**Proposed Temporary Warehouse (Excluding Dangerous Goods Godown) with Ancillary Facilities
and Associated Filling of Land for a Period of 3 Years in "Agriculture" Zone,
Lot 1452 (Part) in D.D. 107 and Adjoining Government Land, Fung Kat Heung, Yuen Long, N.T.**

(S.16 Planning Application No. A/YL-KTN/1192)

Responses-to-Comments

Title: Drainage Proposal - LAYOUT D01

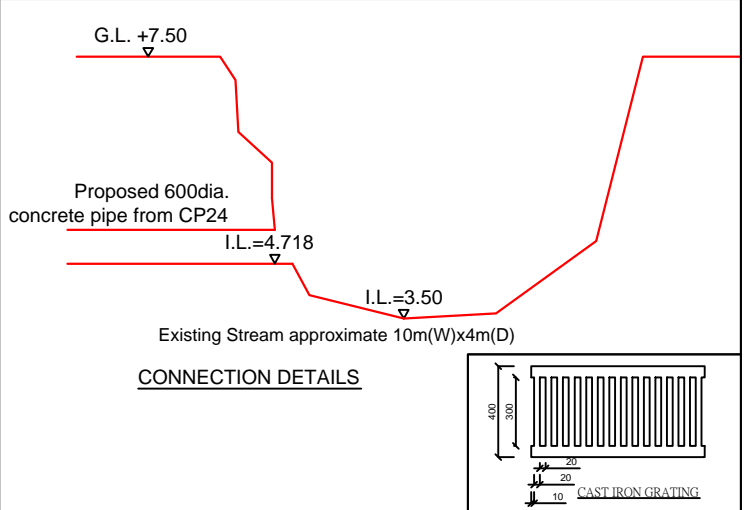
(2)	<p>The applicant should clarify discrepancies of sizes of existing surface channel and the proposed surface channel at the upstream of the proposed catchpit CP4 shown on the submitted</p>

(5)	Drawings (No. :D01 & D03): Peripheral surface channels shall be provided along the site boundary to collect the surface runoff accrued on the application site and to intercept the overland flow from the adjacent lands. It is noted that there is proposed land filling works for the development. Proper surface channels should be provided at the lower level/platform and wall tow to collect the overland flow to/from adjacent areas.

(A) Specific Comments		
(1)	<p>The applicant should clarify discrepancies of the proposed and existing ground levels of the application site shown in the submitted application form and drainage proposal.</p>	<p>Noted. The applicant has proposed a new scheme for the drainage arrangement. Please refer to the revised drainage proposal for details (Annex I).</p>

- Note:**
- Catchpits (CP4, CP16 & CP17) with desilting facility shall follow CEDD standard drawing No. C2406I.
 - Catchpit and UC follows Typical Details of Geotechnical Manual for Slope Fig.8.10 and Fig.8.11 respectively.

- Fence Wall to be erected (if any) shall be Open-bottom type.
 - Max. 200mm, 600mm and 400mm concrete paving to be paved on A/YL-KTN/995, A/YL-KTN/1181 and A/YL-KTN/1167 respectively.

Catchment Area Plan

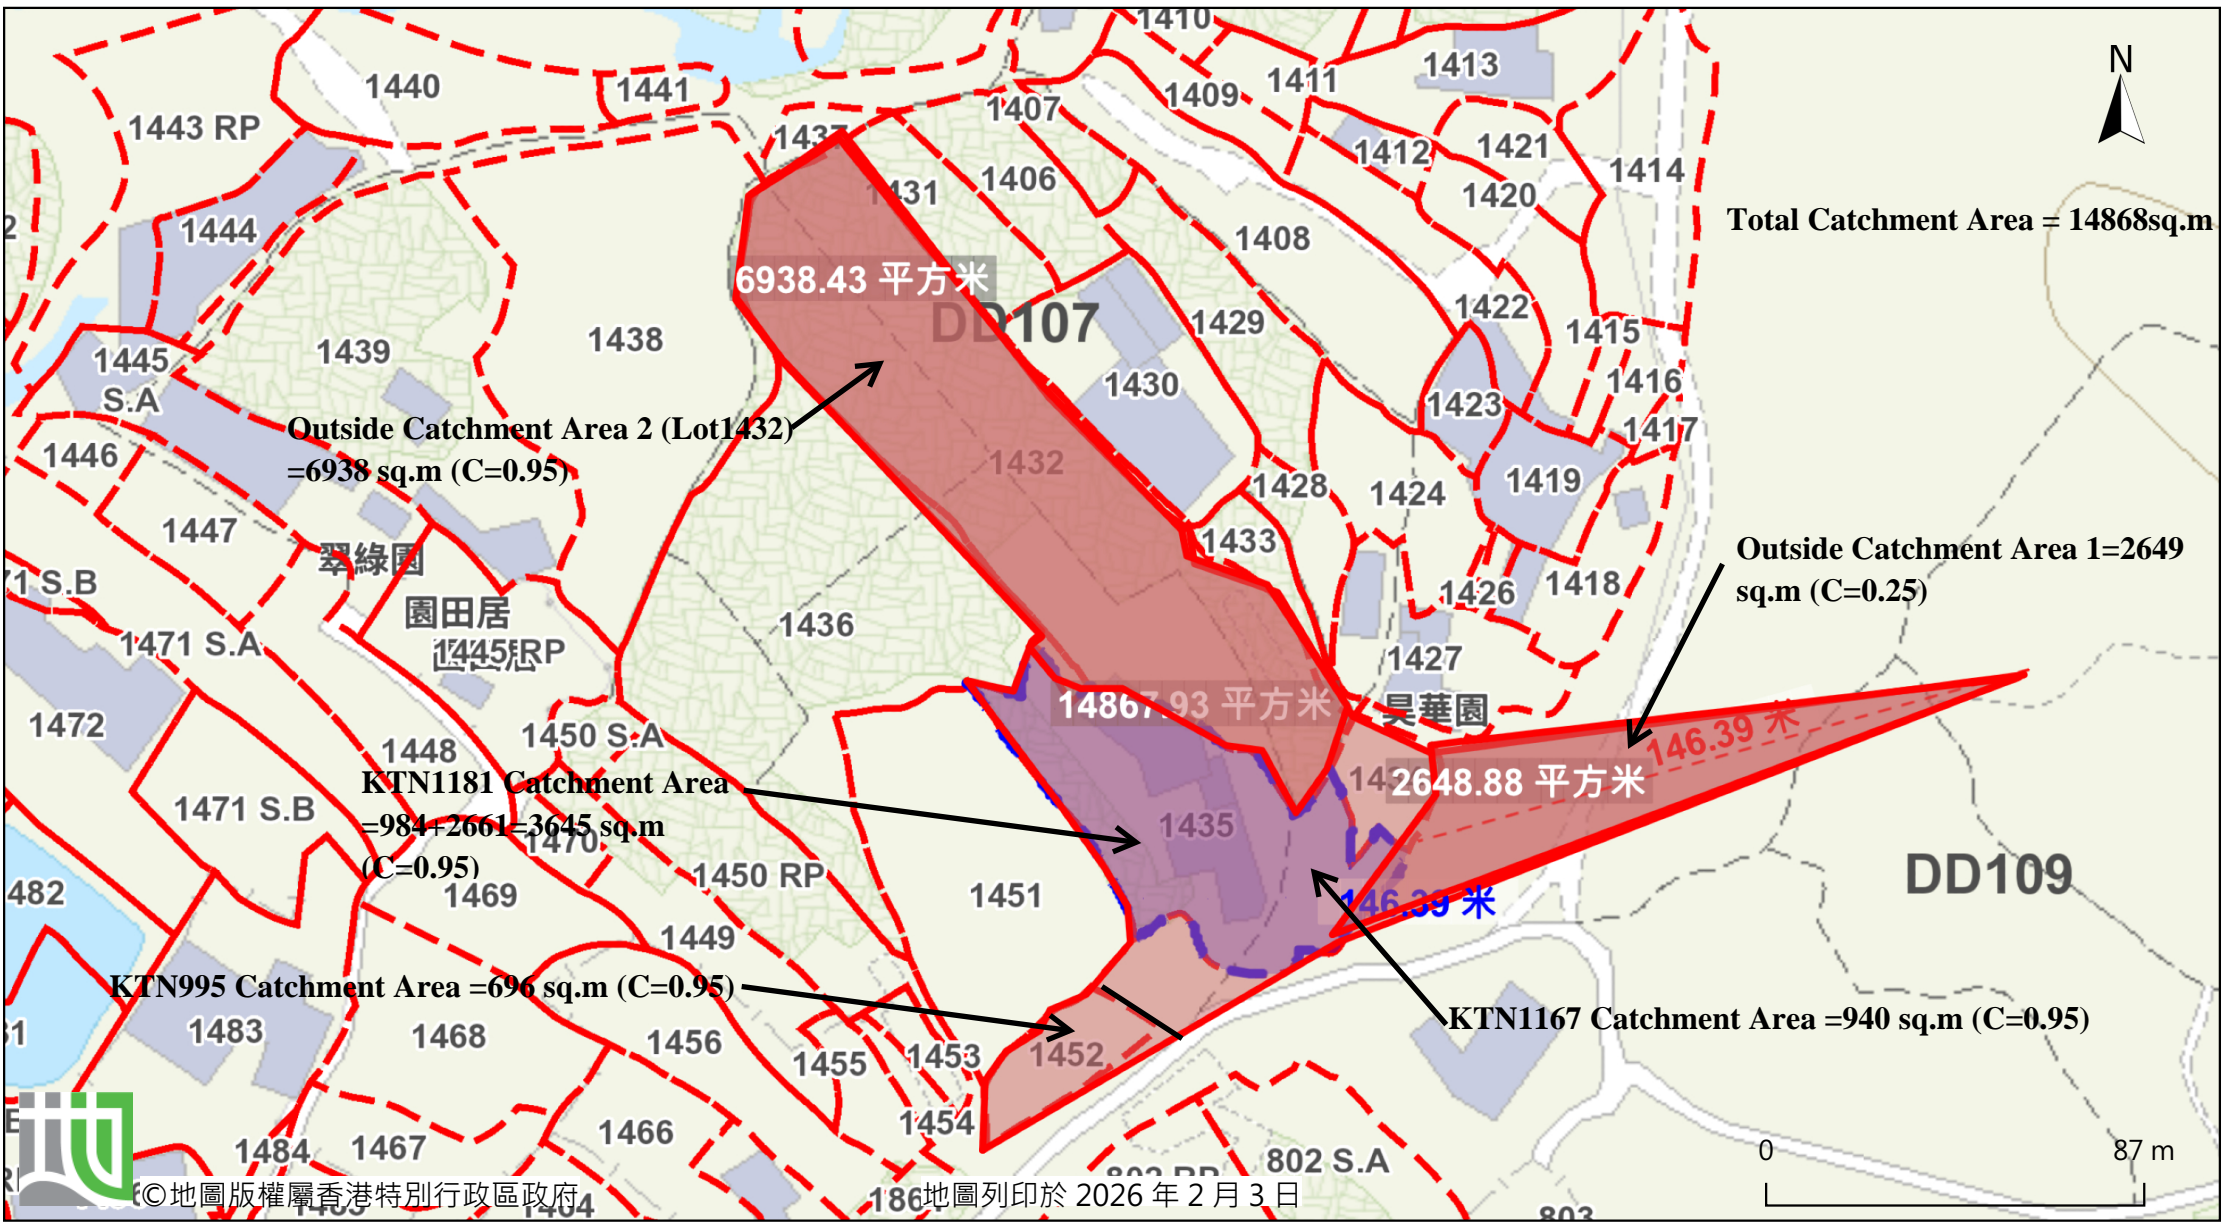
(4)	The ground to the northeast of the application site is generally higher. According to the topography around the subject site , external catchment shall be greater than the one adopted in the submitted hydraulic calculation. The applicant should update hydraulic calculation.

1	Catchment Area for KTN995, Area	= 696	m ²	(C= 0.95)
2	Catchment Area for KTN1167, Area	= 940	m ²	(C= 0.95)
3	Catchment Area for KTN1181, Area	= 3645	m ²	(C= 0.95)
4	Outside Catchment Area 1, Area	= 2649	m ²	(C= 0.25)
5	Outside Catchment Area 2 (Lot1432), Area	= 6938	m ²	(C= 0.95)
	H	= 18.767		(H=(37-9.6)/146*100)
	L	= 146	m
